# HISTORIC AND DESIGN REVIEW COMMISSION

**HDRC CASE NO:** 2018-451  
**ADDRESS:** 607 E LOCUST  
**LEGAL DESCRIPTION:** NCB 1735 BLK 14 LOT 3  
**ZONING:** MF-33 H  
**CITY COUNCIL DIST.:** 1  
**DISTRICT:** Tobin Hill Historic District  
**APPLICANT:** Jose Calzada/Architectura SA  
**OWNER:** Rafael Saavedra Sada/Aster Development LLC  
**TYPE OF WORK:** Construction of a 3-story, multifamily structure  
**APPLICATION RECEIVED:** November 14, 2018  
**60-DAY REVIEW:** January 13, 2018  
**REQUEST:**

The applicant is requesting conceptual approval to construct a 3-story multifamily structure on the vacant lot addressed 607 E Locust. The request also includes rear surface parking for approximately 8 cars, additional hardscaping, and landscaping.

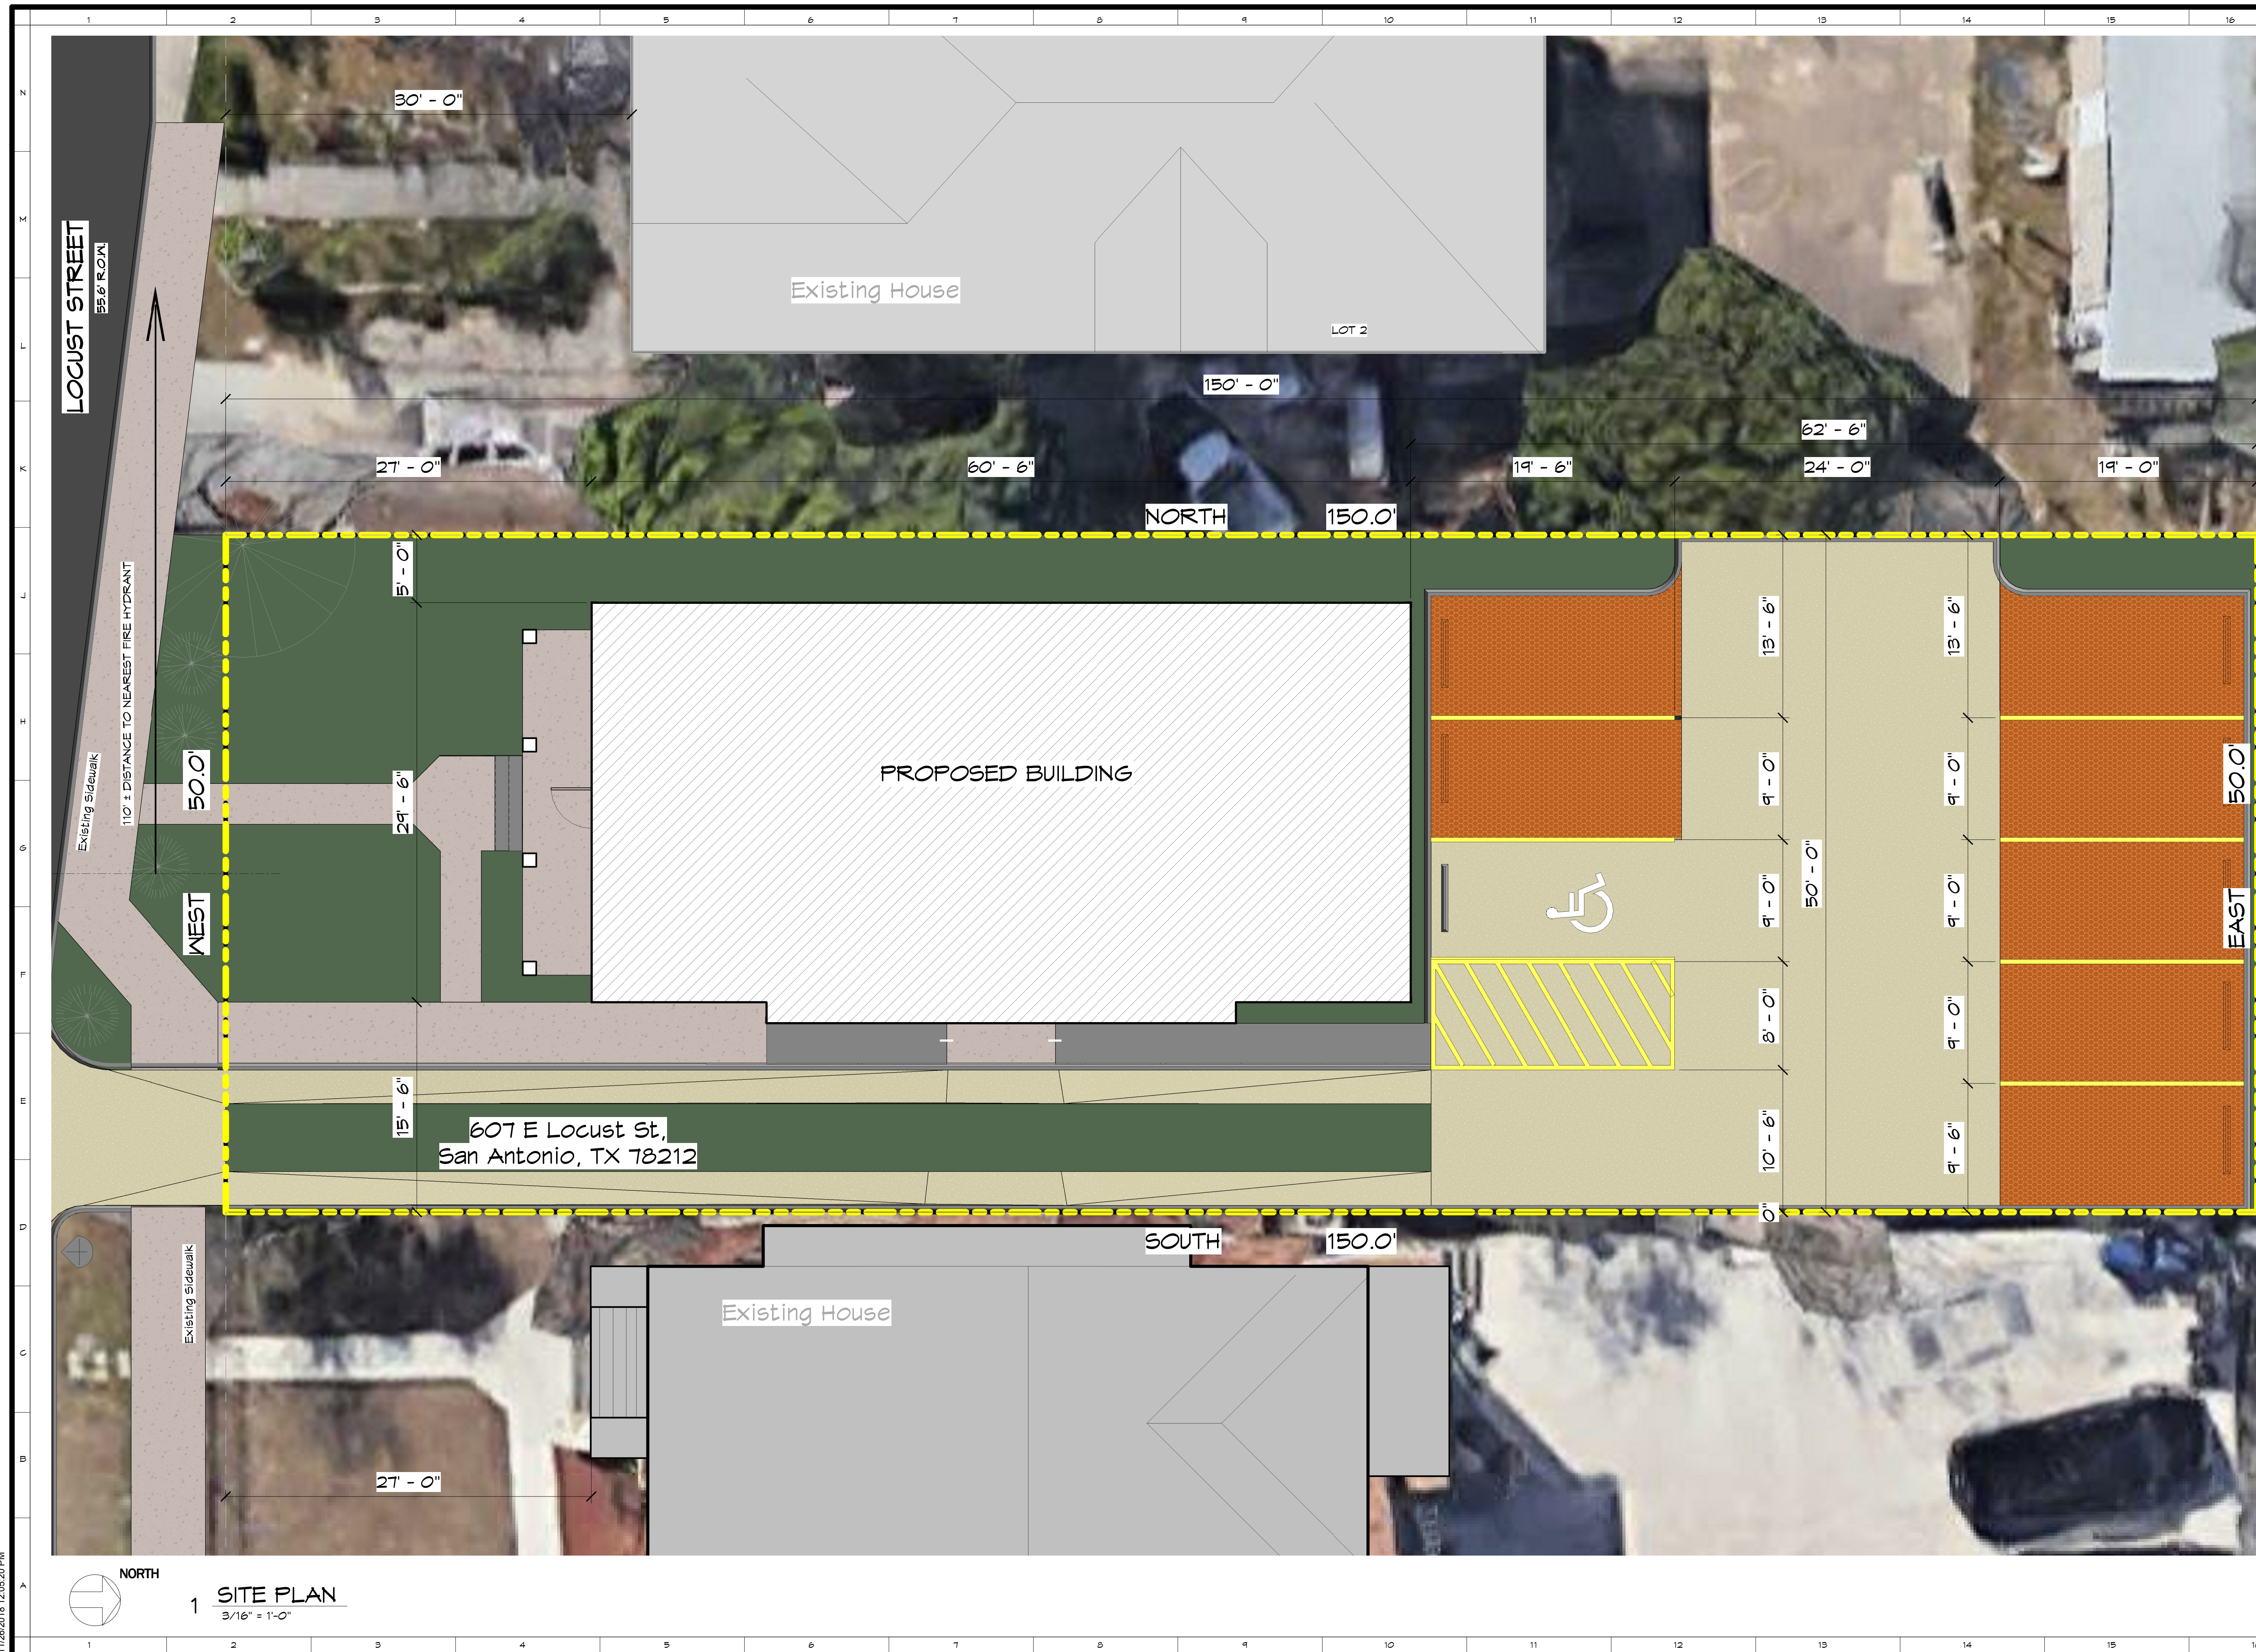
historic structures that feature front yard setbacks of approximately 20-35 feet. Based on the submitted documentation, the neighboring historic structures to the east and west have a front setback of approximately 25-27 feet. The applicant has proposed approximately a 25 foot setback. While the proposed setback matches the structure immediately to the east, staff finds that the setback should be increased to match the structure to the west, which is approximately 2 feet deeper.

- q. HARDSCAPING – The applicant has proposed a 12 foot wide central driveway on the eastern edge of the property. The Guidelines state that driveway should be a maximum of 10 feet to comply with the historic development patterns of the district. Staff finds that the width should be reduced. The applicant has also proposed 8 parking spaces in the rear of the lot. The applicant has indicated their intent to incorporate as much pervious cover as possible where feasible. Staff finds that the maximum amount of pervious cover should be employed.

- i. That the applicant increases the front setback to meet or exceed those of neighboring structures as noted in finding e.
- ii. That the applicant modifies the proposed massing and roof forms, particularly on the east and west elevations, to be more consistent with the Guidelines as noted in finding i.
- iii. That the applicant modifies the architectural detailing of the overall proposal to develop an architectural language that is more consistent on each elevation as noted in findings i and n.
- iv. That the applicant modifies the arched window on the front and rear facades to be more consistent with window sizes and patterns in the district as noted in finding k.
- v. That the applicant reduces the proposed driveway width as noted in finding q.

Drawn By:	Author:
Checked By:	Checker:
Job Number:	10-049
EXTERIOR ELEVATIONS	
No.	DATE DESCRIPTION

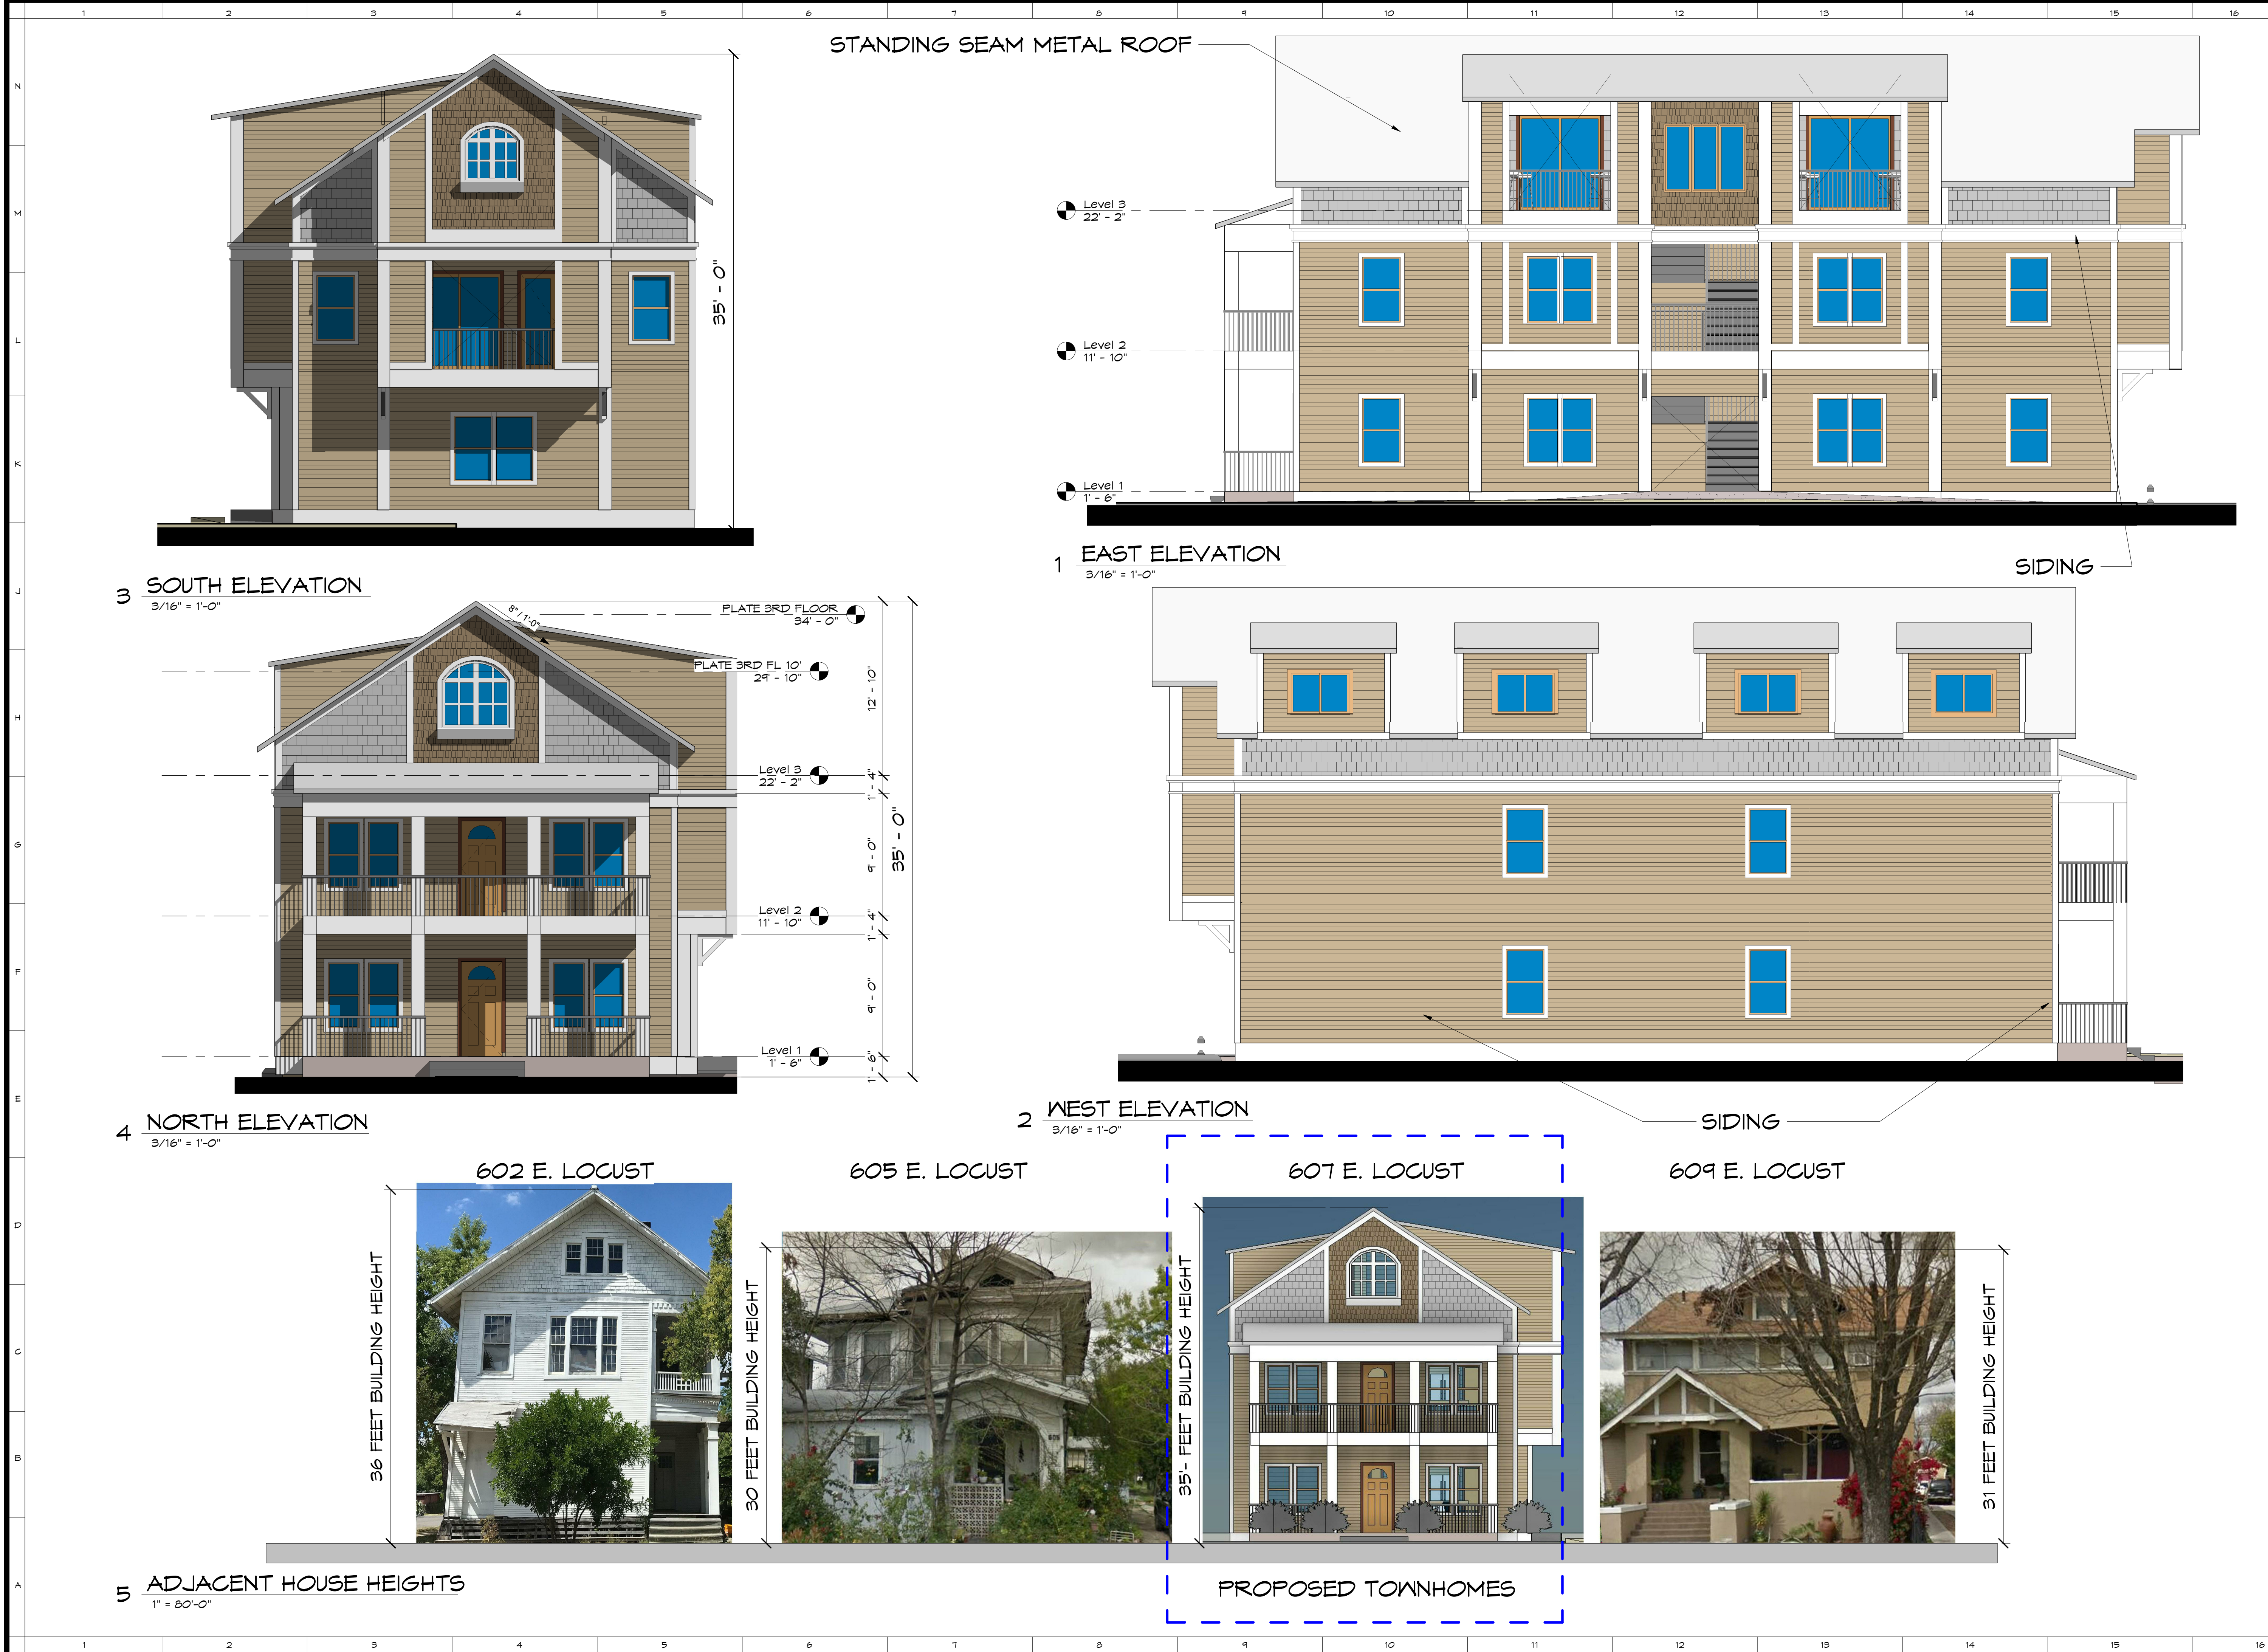
- i. **ROOF FORM** – The applicant has proposed a front and rear gable form with a low-sloping shed gable on the east elevation and four dormer-style elements on the west elevation. Staff finds that the gable configuration is a familiar element to the district and evident on historic precedents along E Locust. However, the side roof forms are a departure from traditional patterns. The low-sloping shed roof on the east elevation features a design expression that deviates from the front roof form elements. The dormer-style elements on the west elevation do not feature traditional dormer detailing, such as recessing into the primary roof form. As proposed, the overall relationship of the roof forms are not consistent with precedents in the district or the Historic Design Guidelines. Staff finds that the architectural relationship of these forms should be more consistent on each elevation and share the same architectural language.

- j. **PORCH** – The applicant has proposed a double height front porch on the primary façade. The porch features a traditional railing based on the submitted renderings with a depth of approximately 5 feet. According to the Historic Design Guidelines, new construction should not attempt to mirror or replicate historic features, and new structures and design elements should not be so dissimilar as to distract from or diminish the historic interpretation of the district. The conceptual porch configuration pulls from the historic structure located 2 houses to the west. Staff finds the porch element on the front façade to be generally consistent with the Guidelines, but finds the entrance configuration on the east façade to be a deviation from traditional patterns.

- k. **WINDOW & DOOR OPENINGS** – According to the Historic Design Guidelines for New Construction, window openings with a similar proportion of wall to window, as compared to nearby historic facades, should be incorporated. Similarity is defined by windows that are no larger than 25% in size and vary no more than 10% in height to width ratio from adjacent historic facades. The applicant has proposed several window and door openings that generally feature sizes that are found on historic structures. However, the front and rear elevation contains an arched window on the third story that deviates from traditional configurations. Staff finds that this window should be modified to be more consistent with those traditional found on 2-1/2 story structures in the district.

elements that are consistent with the Guidelines, particularly the front porch detailing, primary gable configuration, and decorative bracketing and shingle detailing. However, the roof forms and façade plane treatments feature differing architectural language and detailing, and the east and west elevations are in discord from the front and rear elevations. Staff finds that the architectural details should be consistent across all elevations.
